5.0 REVISIONS TO THE REVISED DRAFT EIR

As indicated in the Introduction to this document, the entirety of the Scott Ranch Project Final EIR consists of the RDEIR and its appendices, and this Response to Comments document. Thus, changes to the RDEIR presented below supersede the corresponding original text of the RDEIR. Throughout this chapter, newly added text is shown in underline format, and deleted text is shown in ~~strikeout~~ format. Changes are listed in the order in which they appeared in the RDEIR (e.g., **Chapter 1.0, Introduction; Chapter 2.0, Executive Summary**).

UPDATED FIGURE **4.3-2**

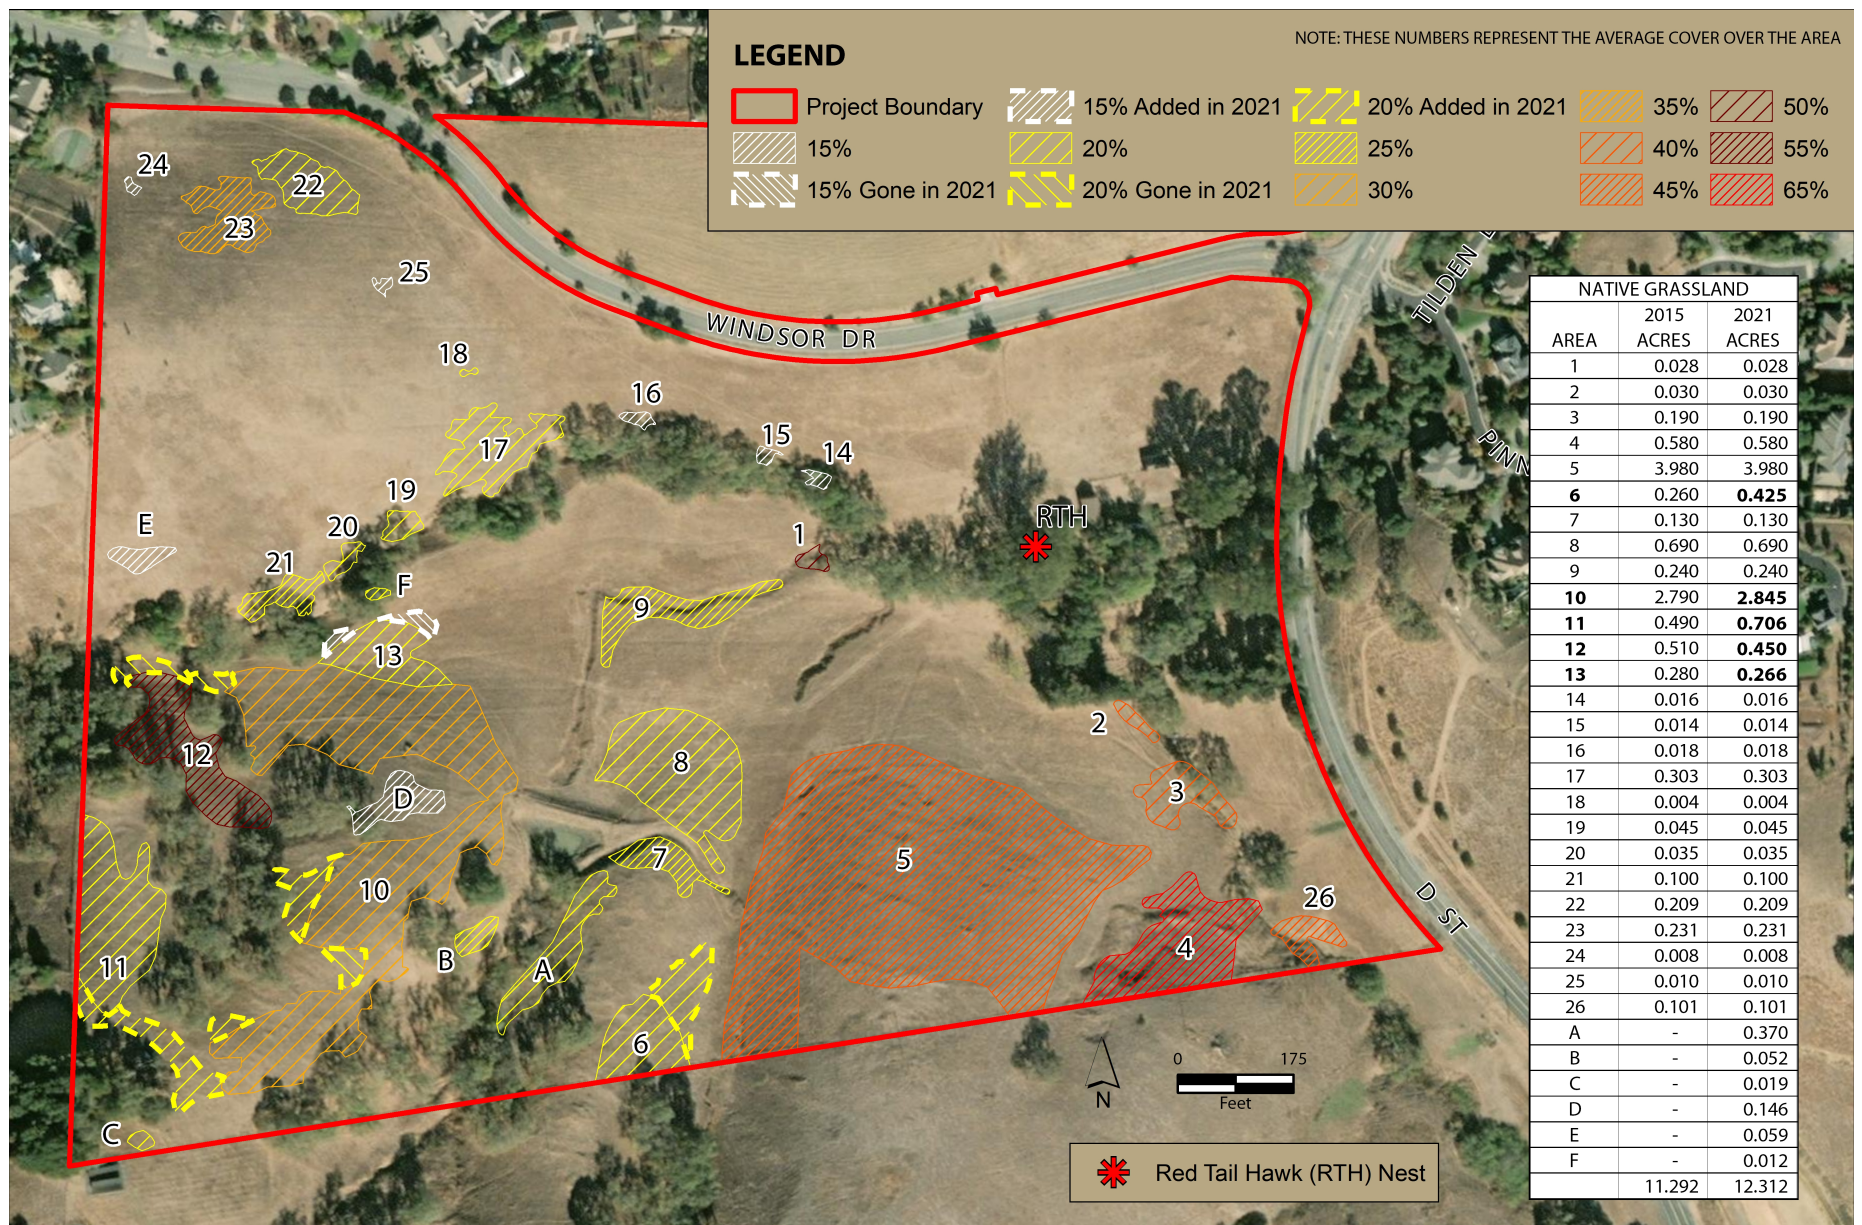
Figure 4.3-2:

Figure number has been revised as follows: **Updated Figure 4.3-2**.

Figure has been updated to show the revised grassland footprints according to the surveys conducted after the publication of the RDEIR.

UPDATED FIGURE 4.3-3

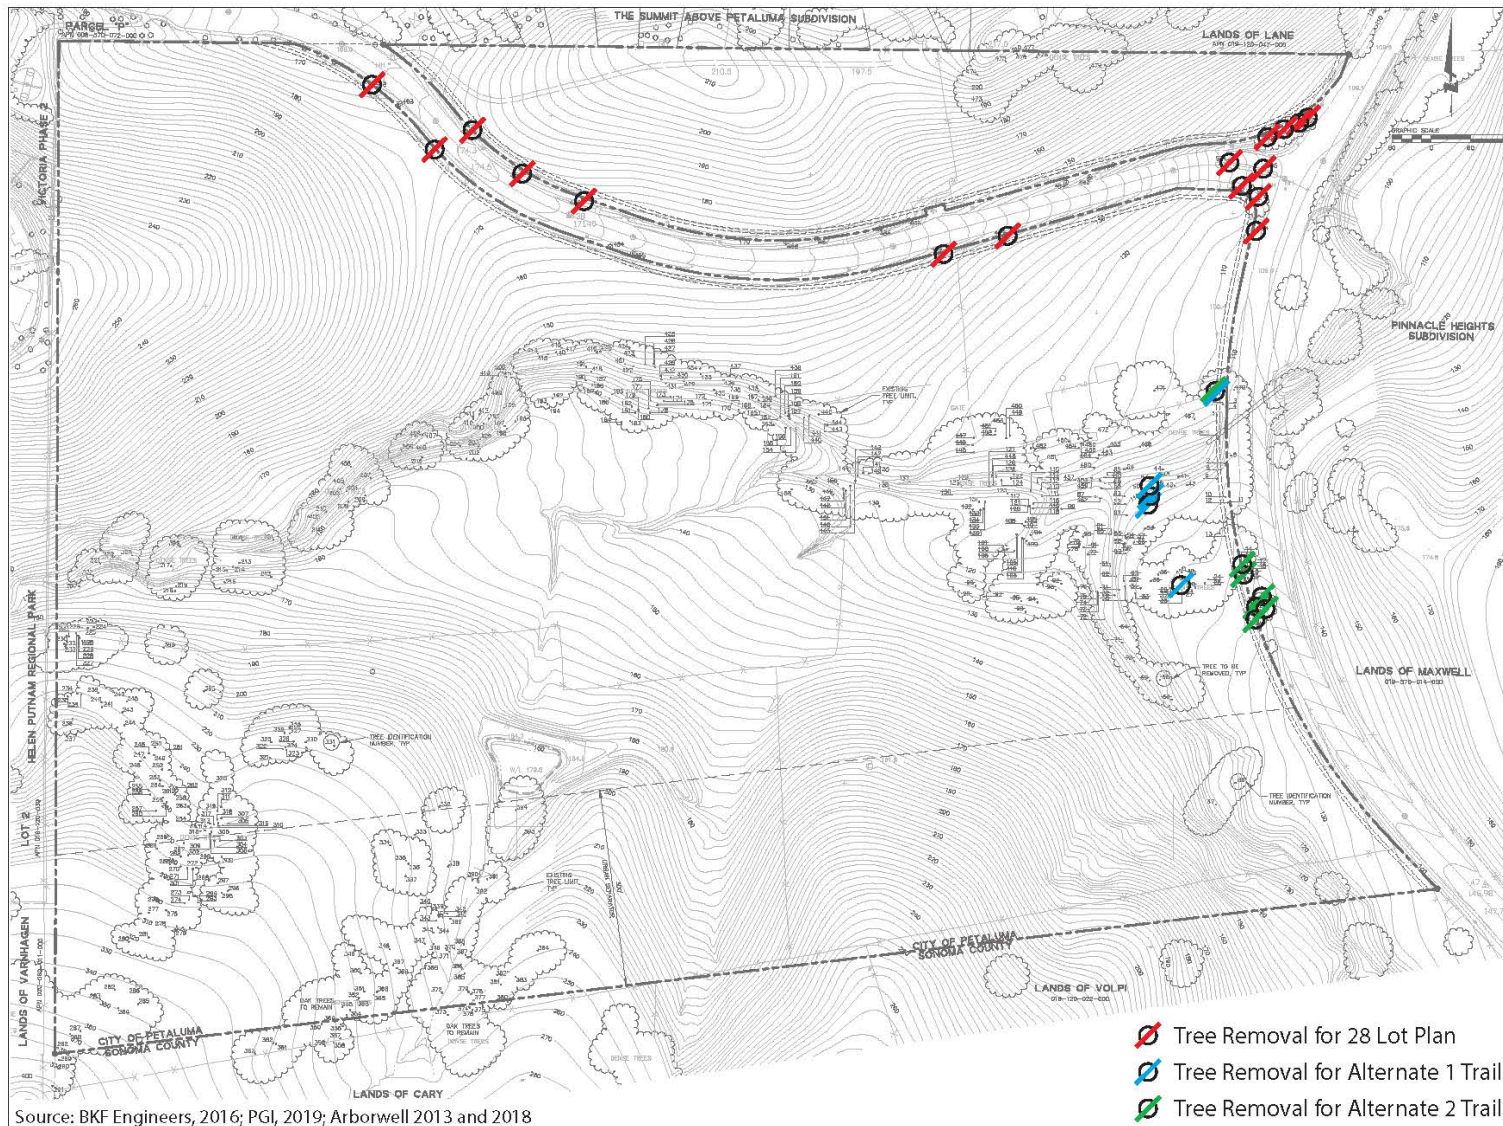
Figure 4.3-3:

Figure has been replaced to show the correct number of trees that would be removed as part of the residential component. As revised, two trees along the south side of Windsor Drive would not be removed. The residential component would result in the removal of 16 trees onsite (with up to 3 trees as part of the offsite sidewalk improvements not shown on the figure). The park extension component would result in the removal of 11 trees.

UPDATED FIGURE 4.13-11

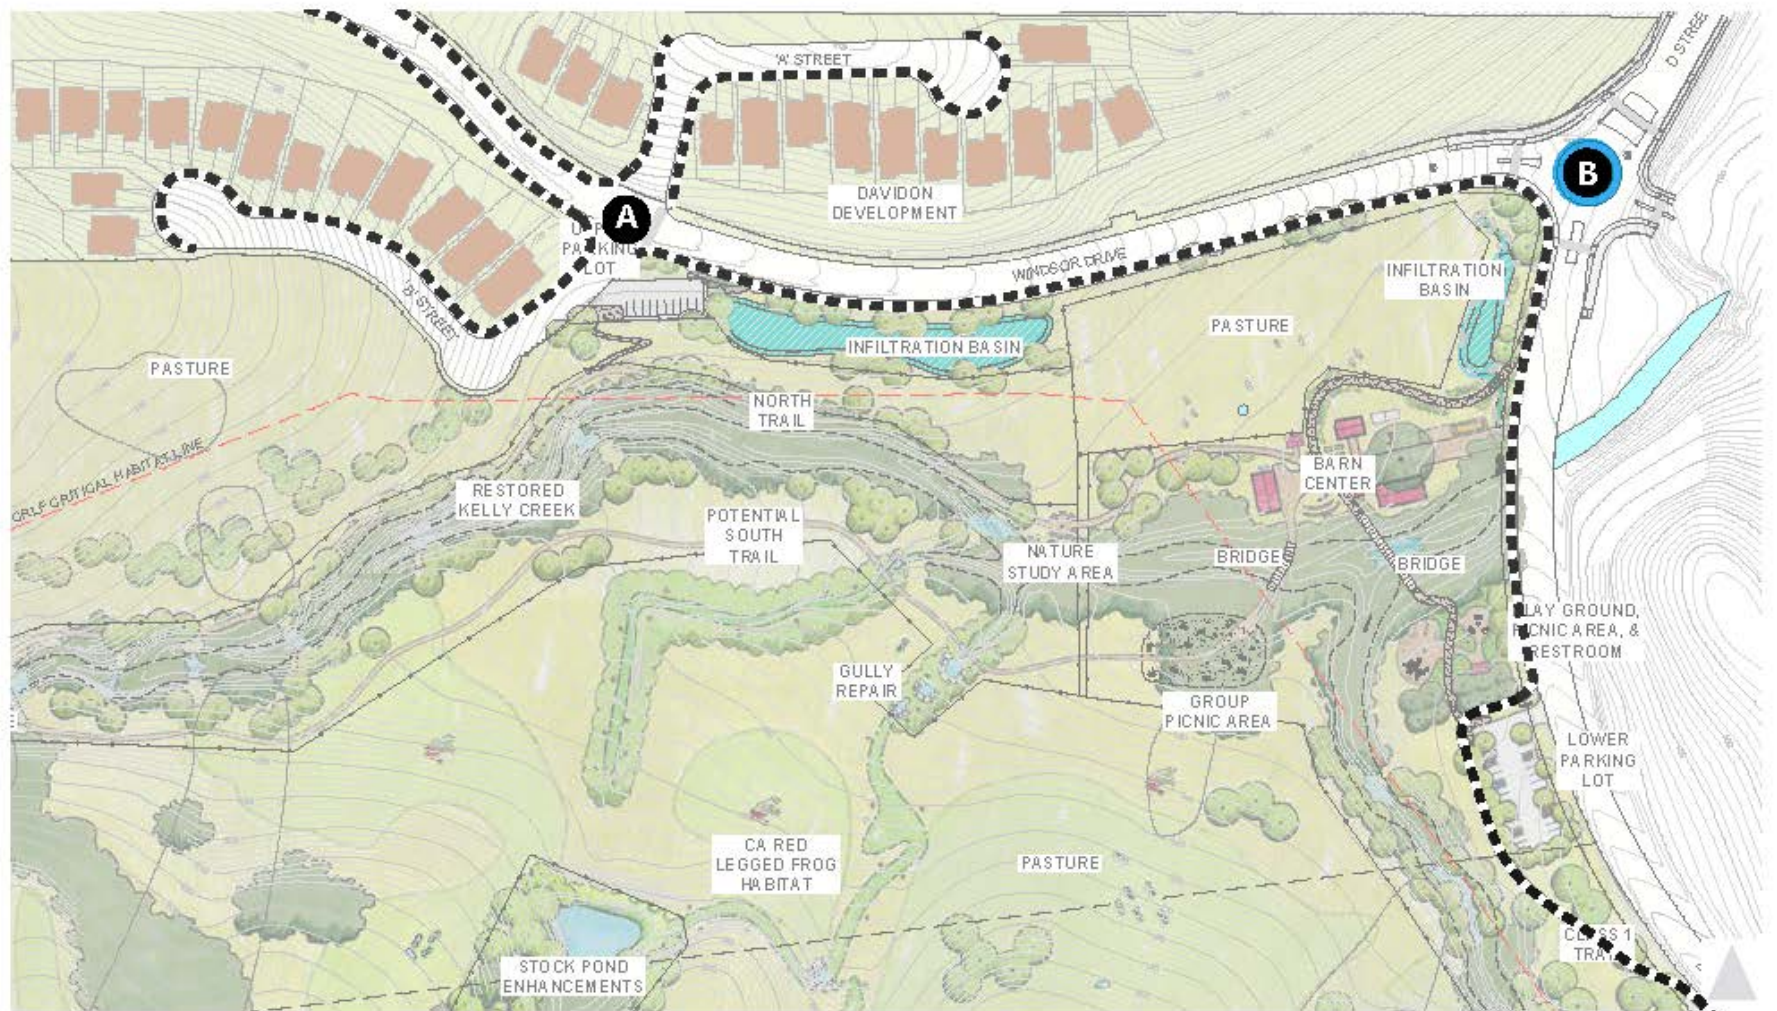
Page 4.13-57, Figure 4.13-11:

Figure has been updated to show the revised footprint of the residential component.

Figure Number has been revised as follows: **Updated Figure 4.15-3**

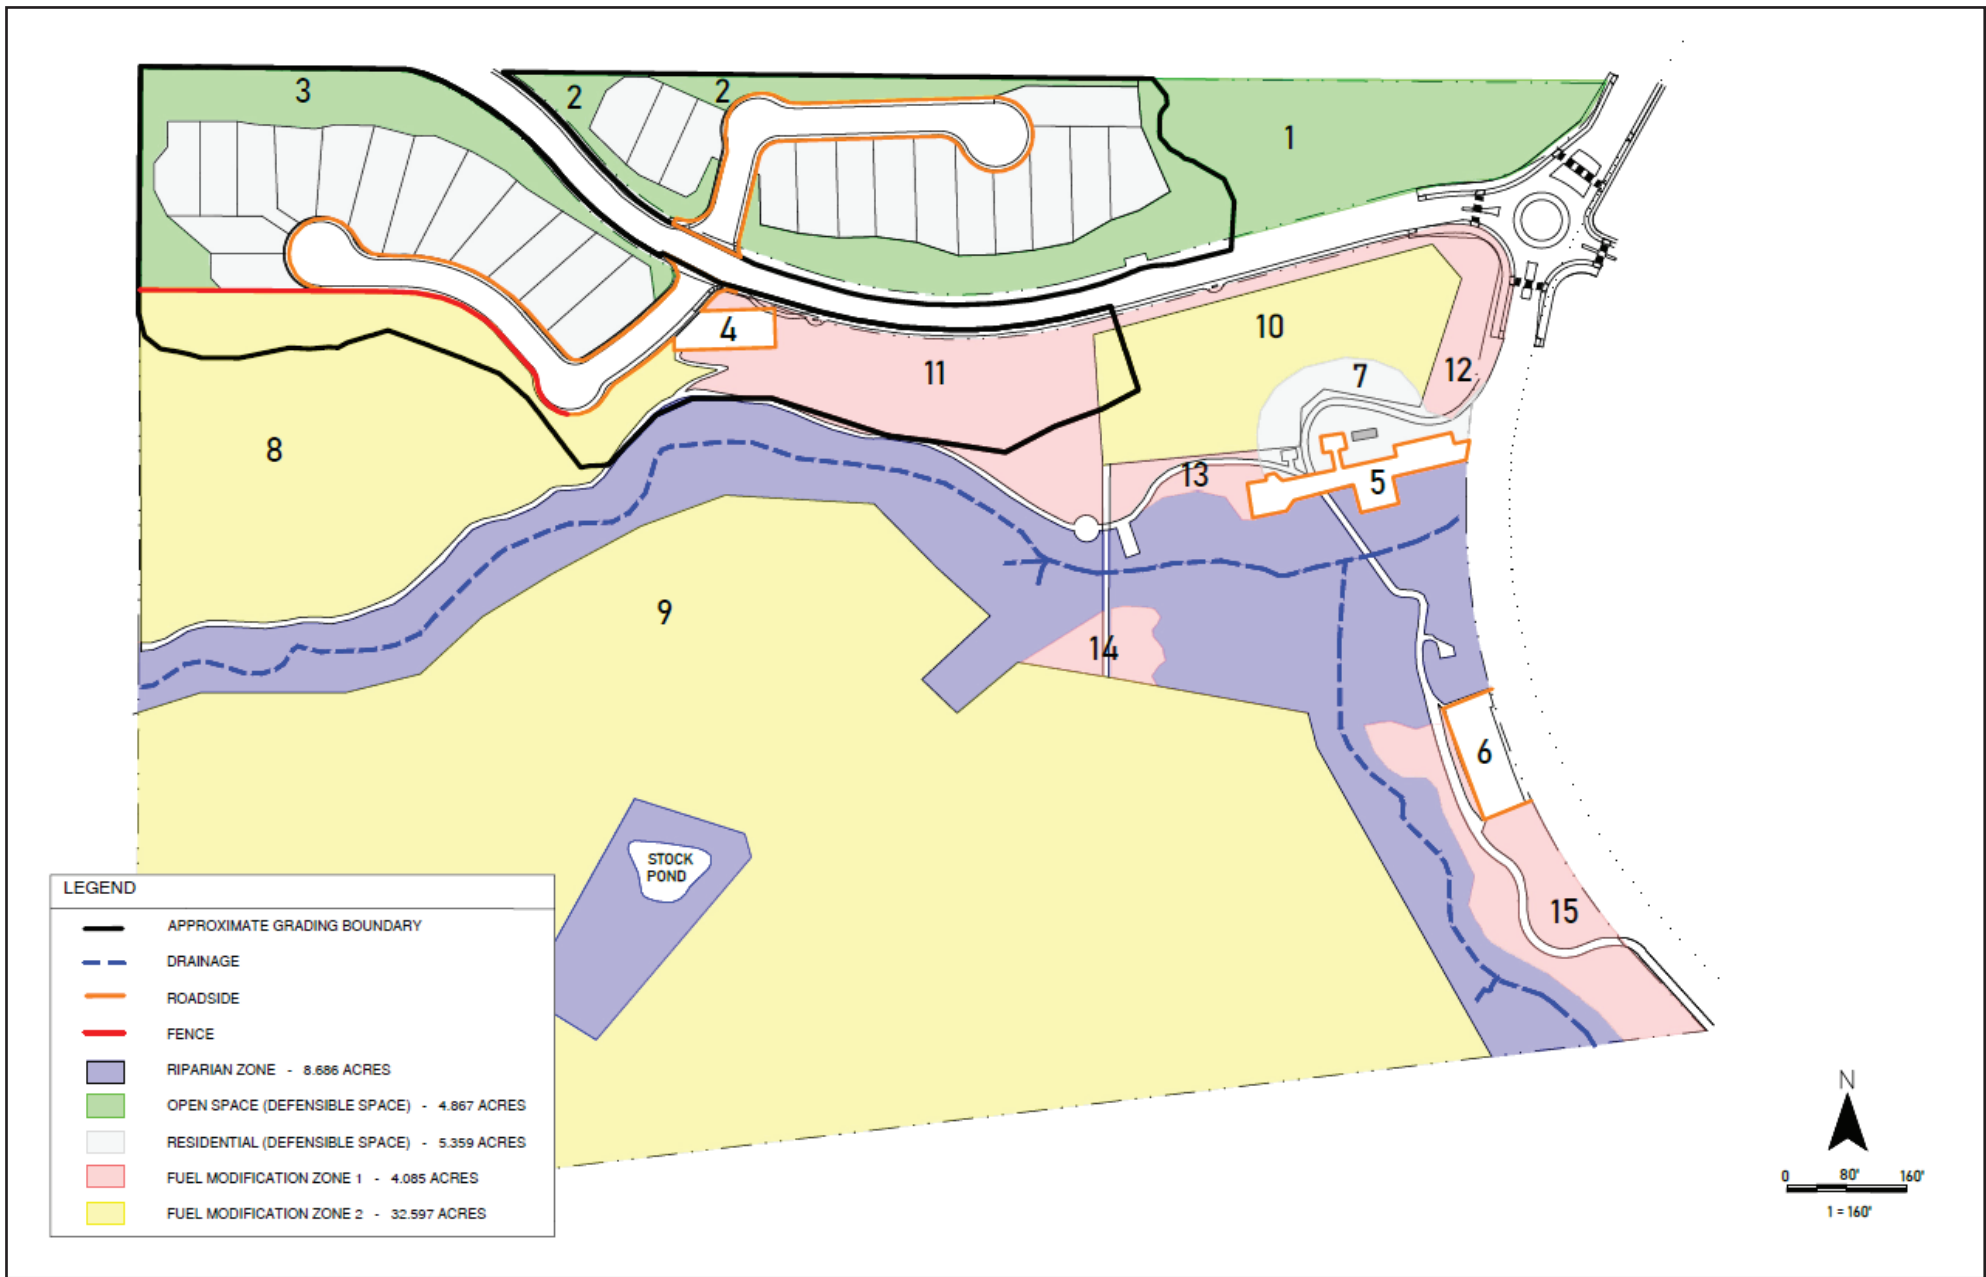
Figure 4.15-3:

Figure has been updated to show the updated fuel management zones per the *Revised Fuel Management Plan*.
